**Subject:** San Mateo Park Elementary School HVAC Replacement  
San Mateo - Foster City School District  
Aedis Project No. 2021011.08  
DSA Application #01-120214

### ADDENDUM NO. 1

San Mateo Park Elementary School HVAC Replacement  
San Mateo – Foster City School District  
Aedis Project No. 2021011.08

SHEET # AD1-  
MP5.02

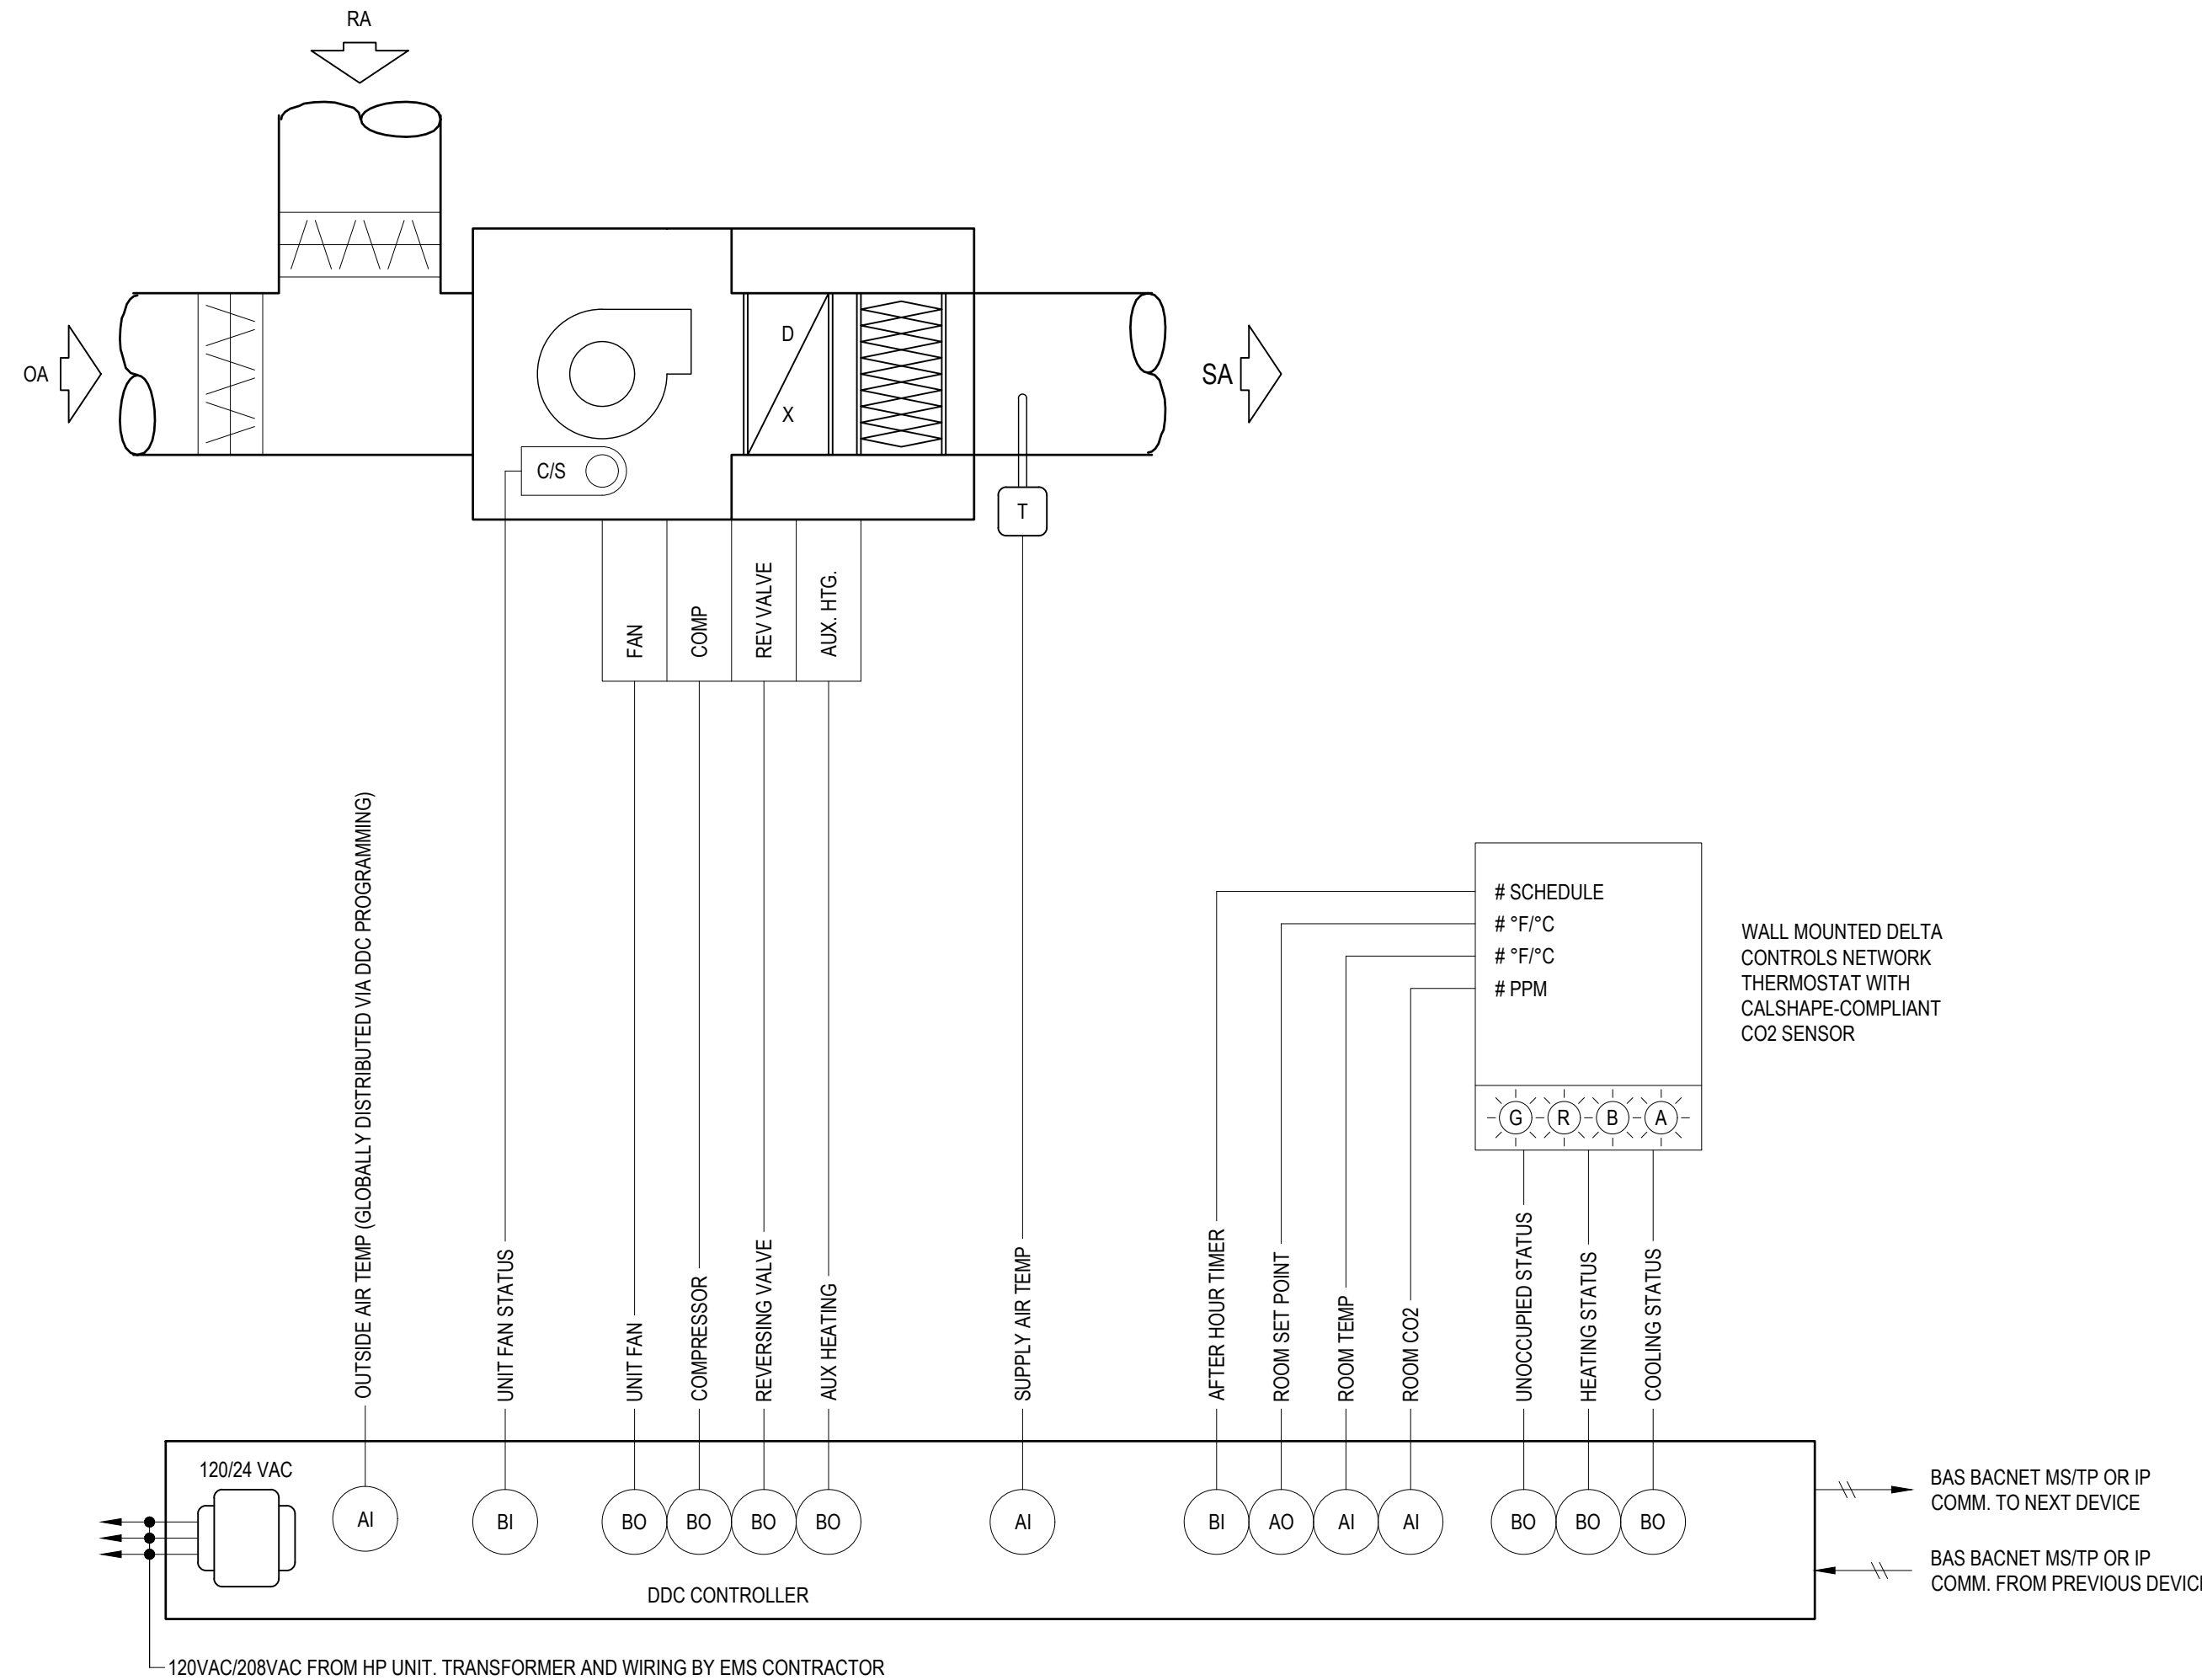
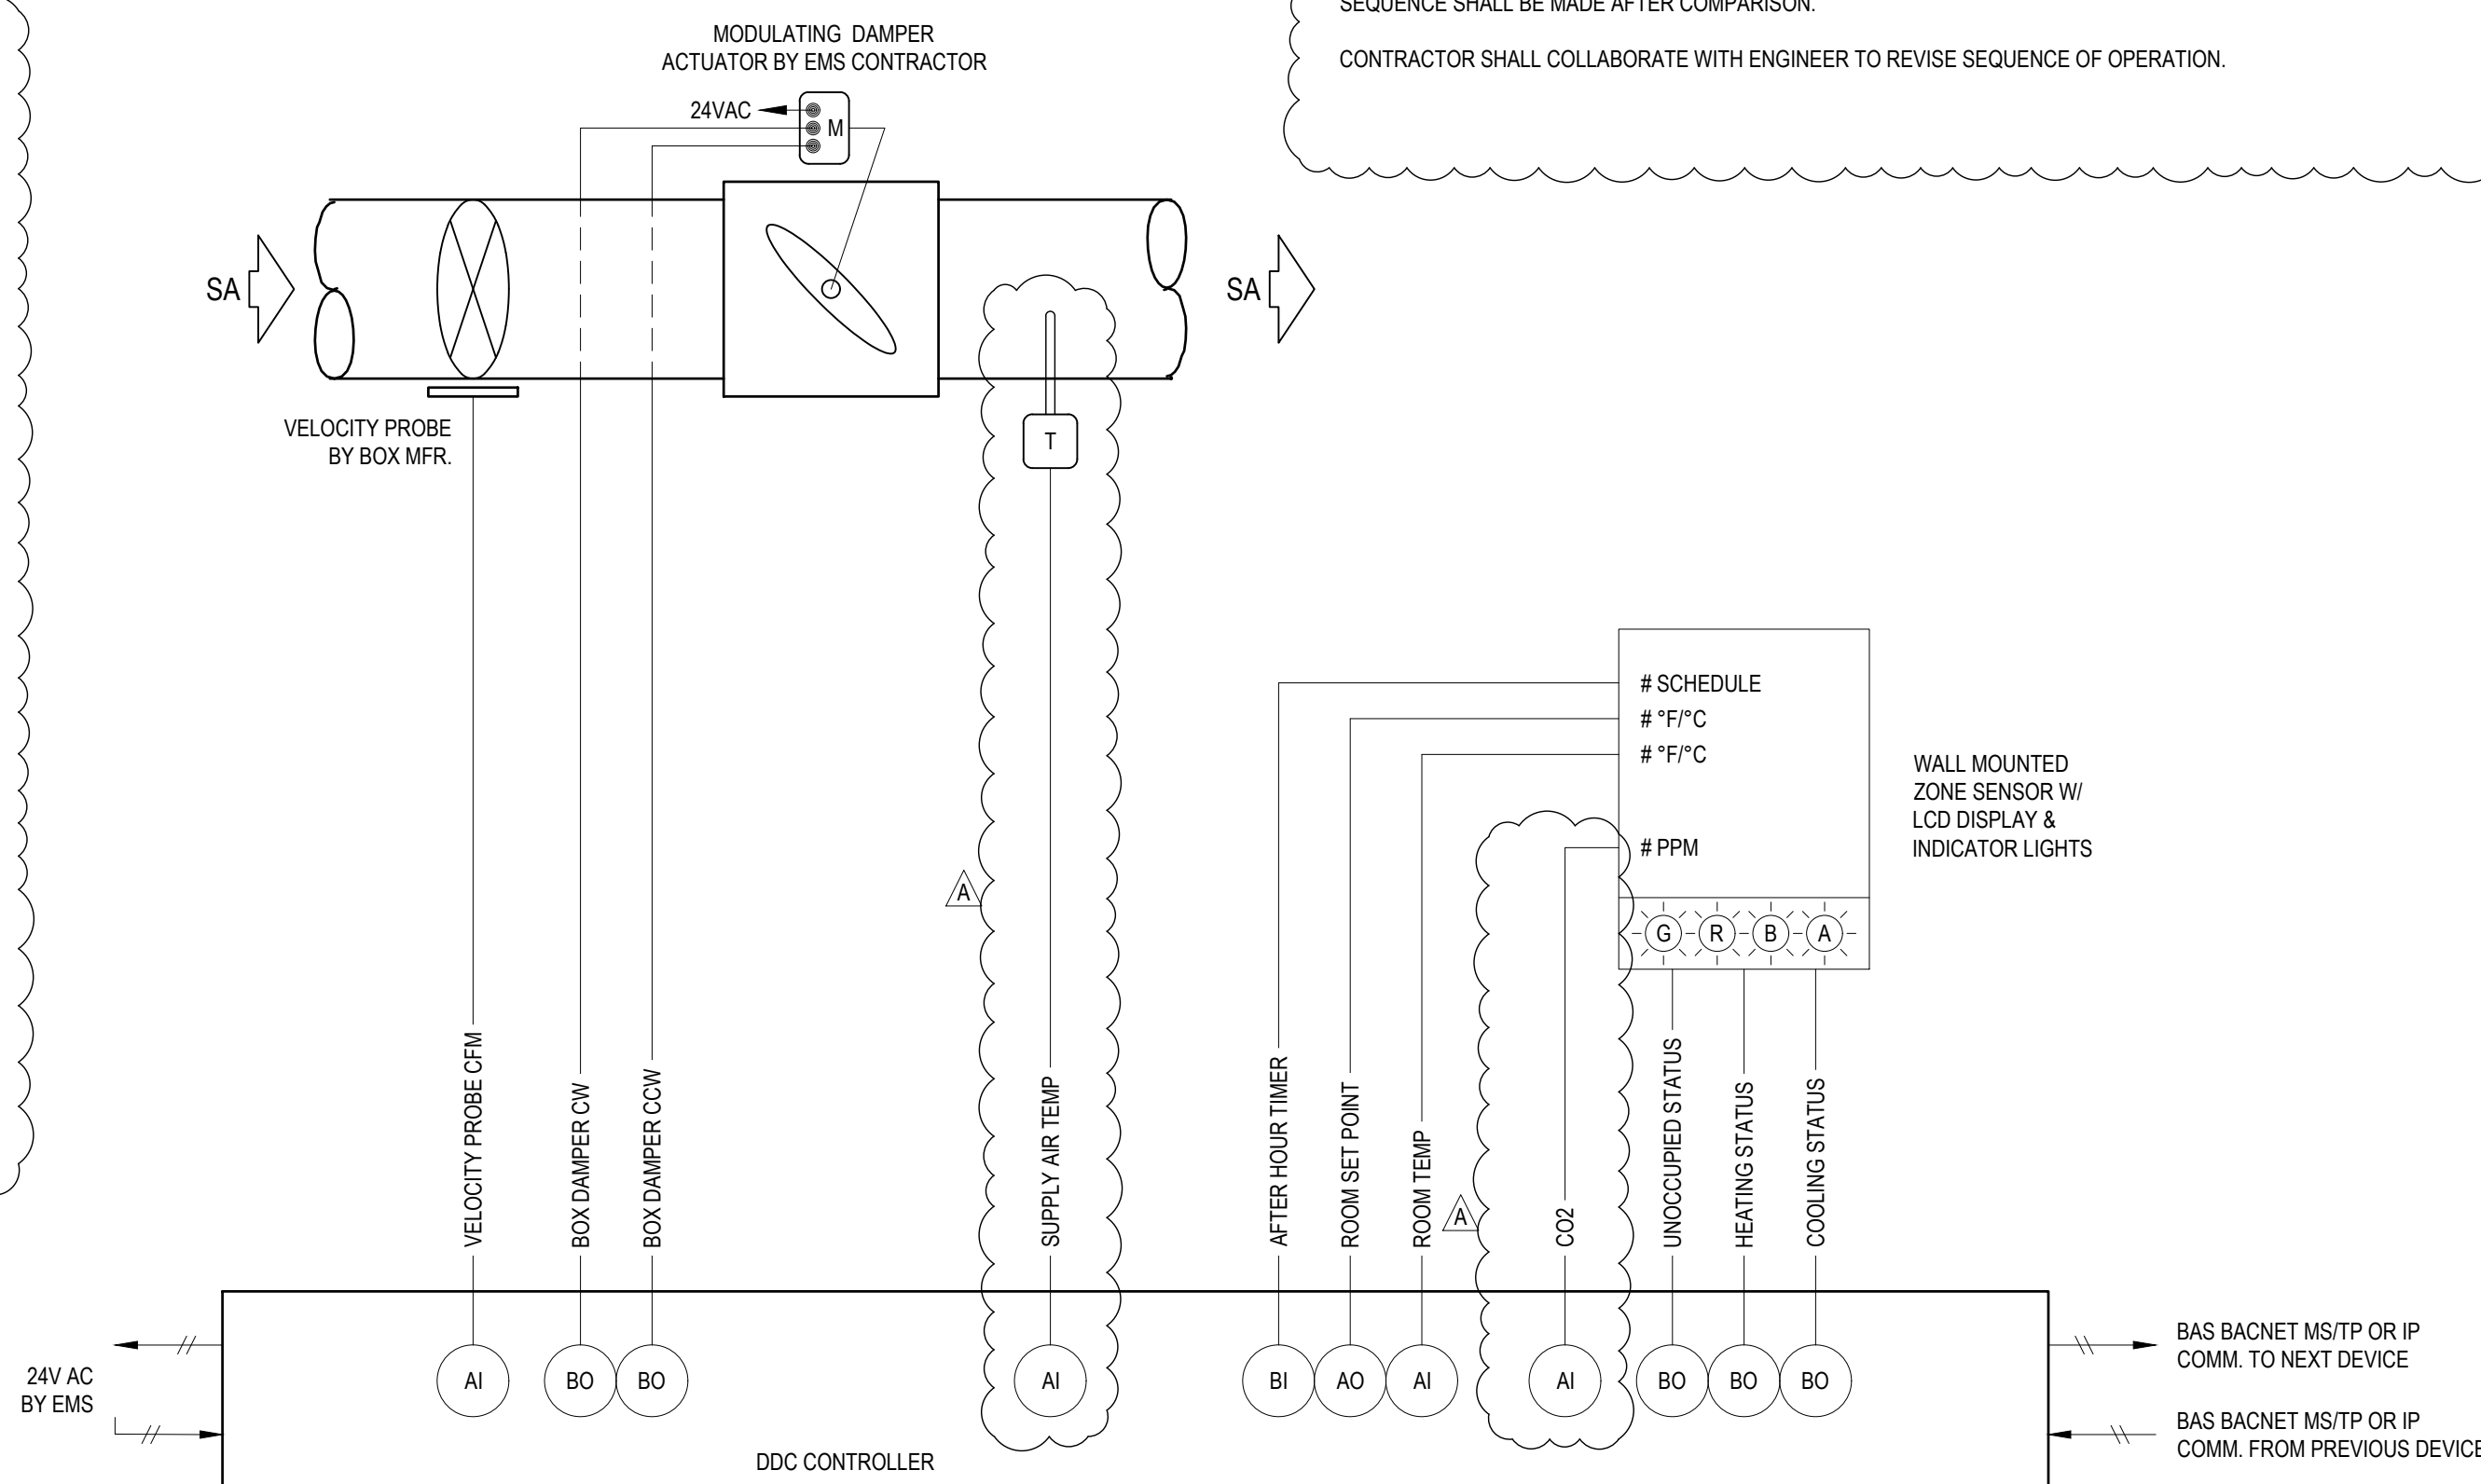
Revise: Sequence of Operation at Zone Damper Control Schematic as shown per AD1-MP5.02

Add: Notes to Zone Damper Control Schematic as shown per AD1-MP5.02

Add: Supply Air Temp and CO2 added to controls at Zone Damper Control Schematic as shown on AD1-MP5.01
